813 - 913 Wallgrove Road Traffic Assessment Addendum

This letter forms an addendum to the previous *813-913 Wallgrove Road Traffic Impact Assessment* report (GHD, 2013), and provides a summary an additional traffic and transport assessment of the revised site access and parking arrangements. An assessment of a proposed interim access arrangement to the Gazcorp site from the SLR is also provided.

Gazcorp Industrial Estate [SSD 5248] – Issues identified following the exhibition of the EIS

Figure 1 Interim (2021) Wallgrove Road/Gazcorp Access Intersection Layout

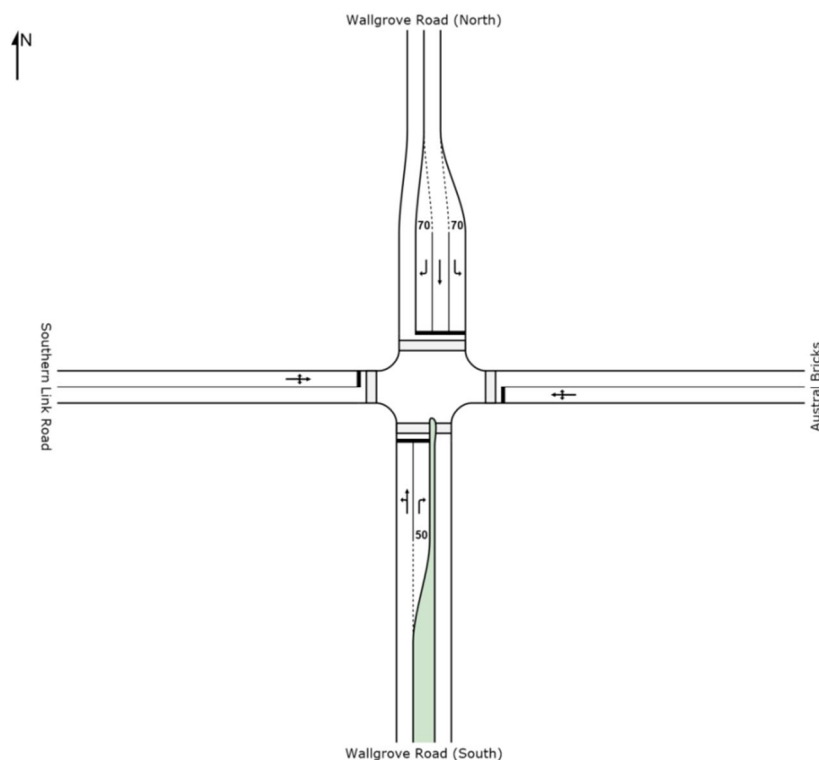
Gazcorp is proposing a permanent single access point off Wallgrove Road. Access to the site should be off the Southern Link Road (SLR), with only interim access off Wallgrove Road until such time as the SLR is constructed between the intersection of Wallgrove Road/ SLR and the Gazcorp access point off the SLR. Access to the site from the SLR is preferred as Wallgrove Road is the higher-order Road and it is important to preserve the efficient functioning of Wallgrove Road by minimising the number of potential new intersections.

A temporary access driveway would provide access to the Gazcorp site, which would form the western approach of a signal controlled intersection with Wallgrove Road and the Austral Bricks access. The interim intersection arrangement assessed in the SIDRA analysis is shown diagrammatically at Figure 1.

Figure 7 Revised Wallgrove Road/SLR Interim Intersection Layout

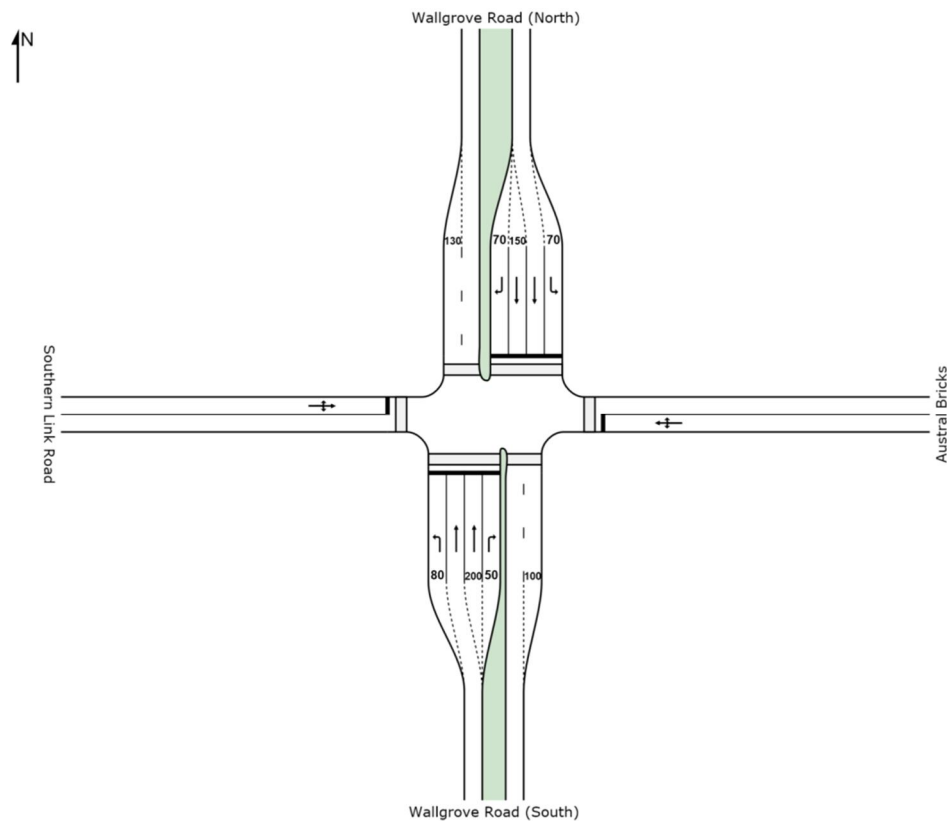
As shown in Table 1 the interim Wallgrove Road/Gazcorp site access intersection is expected to operate at LOS F for both AM and PM peak hour under the forecast 2021 traffic conditions.

A revised interim layout at Wallgrove Road/Gazcorp access/Austral Bricks access intersection has been assessed, which provides two lanes on the intersection departure for 100 metres in each direction along Wallgrove Road. This revised interim layout is shown in Figure 7. SIDRA analysis of this intersection arrangement showed that the intersection is expected to operate at an acceptable LOS C during both the AM and PM peak periods. The SIDRA outputs are provided in **Attachment 3**

A revised interim intersection arrangement for the Wallgrove Road/Gazcorp access/Austral Bricks access intersection has been assessed. The revised layout provides two lanes on the intersection departure for 100 metres in each direction along Wallgrove Road. SIDRA analysis of this intersection arrangement showed that the intersection is expected to operate at an acceptable LOS C during both the AM and PM peak periods under this revised arrangement.

Figure 8 Revised Wallgrove Road/SLR intersection layout

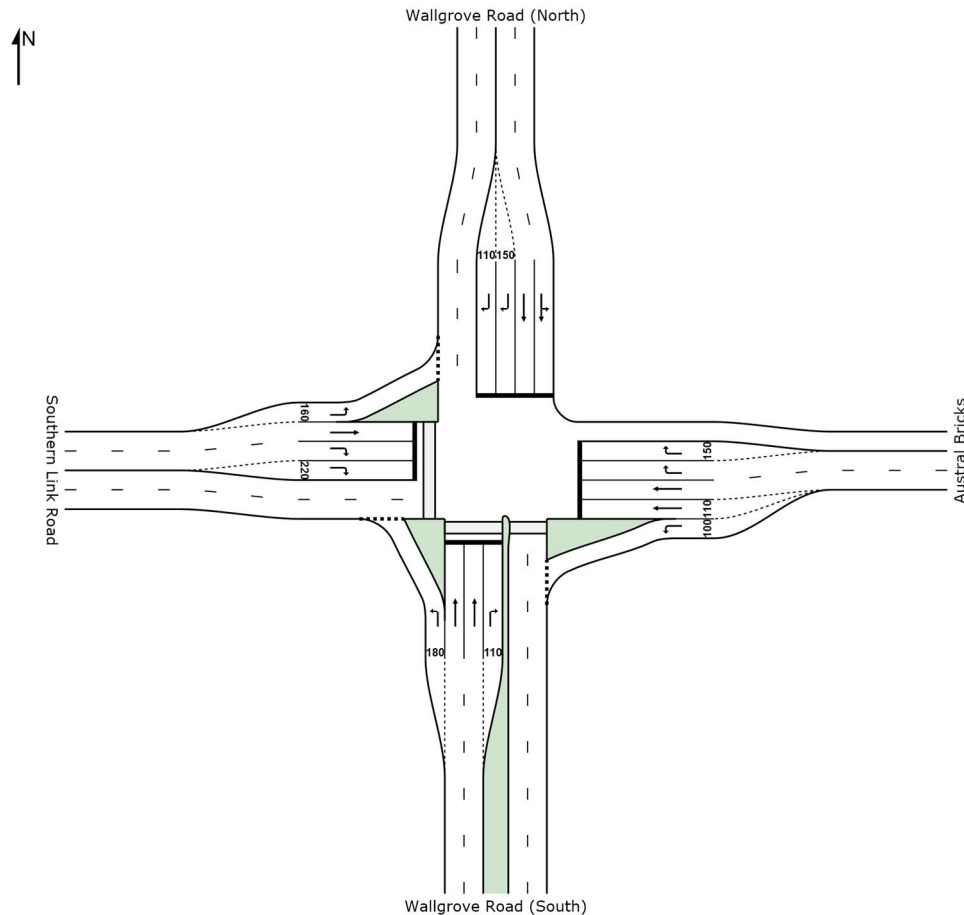
The proposed Wallgrove Road/SLR/Austral Bricks access ultimate design intersection arrangement provided by AECOM is expected to perform at LOS F during both the AM and PM peak periods. This indicates that further improvements would be required at this intersection. SIDRA analysis of the proposed intersection arrangement without the re-distribution of Gazcorp traffic to the proposed SLR also showed that the intersection would operate at LOS F during both the AM and PM peak periods in 2036.

SIDRA modelling was undertaken of a revised intersection arrangement for the proposed Wallgrove Road/SLR intersection for the future year 2036 traffic conditions. The revised layout includes double right turn bays provided at the Wallgrove Road (north) and Southern Link Road (east) approaches.

The revised intersection layout is shown in Figure 8, with SIDRA modelling results provided in **Attachment 3**.

SIDRA analysis was carried out with the revised Wallgrove Road/SLR intersection layout. The SIDRA results indicated that the Wallgrove Road/SLR intersection would operate satisfactorily, with a LoS D during both AM and PM peak hours as shown in Table 3. The SIDRA outputs are provided in **Attachment 3**.

A revised ultimate intersection arrangement for the proposed Wallgrove Road/SLR intersection for the future year 2036 traffic conditions has been assessed. The revised layout includes double right turn bays provided at the Wallgrove Road (north) and Southern Link Road (east) approaches. The SIDRA results indicated that the Wallgrove Road/SLR intersection would operate satisfactorily, with a LoS D during both AM and PM peak hours under the revised arrangement.

Figure 1

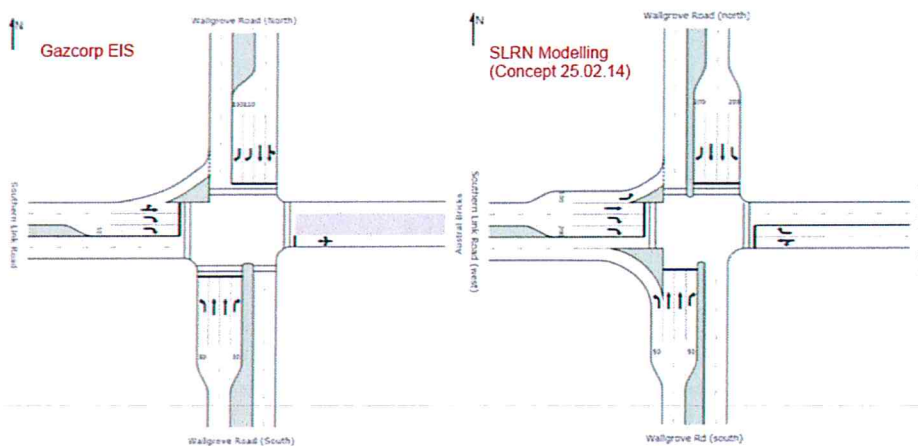
- The EIS modelling does not take into account the most recent SLR concept design (refer to **Figure 1**). The SLR/Wallgrove Road intersection will be based on the current SLR design and accompanying GHD traffic modelling.
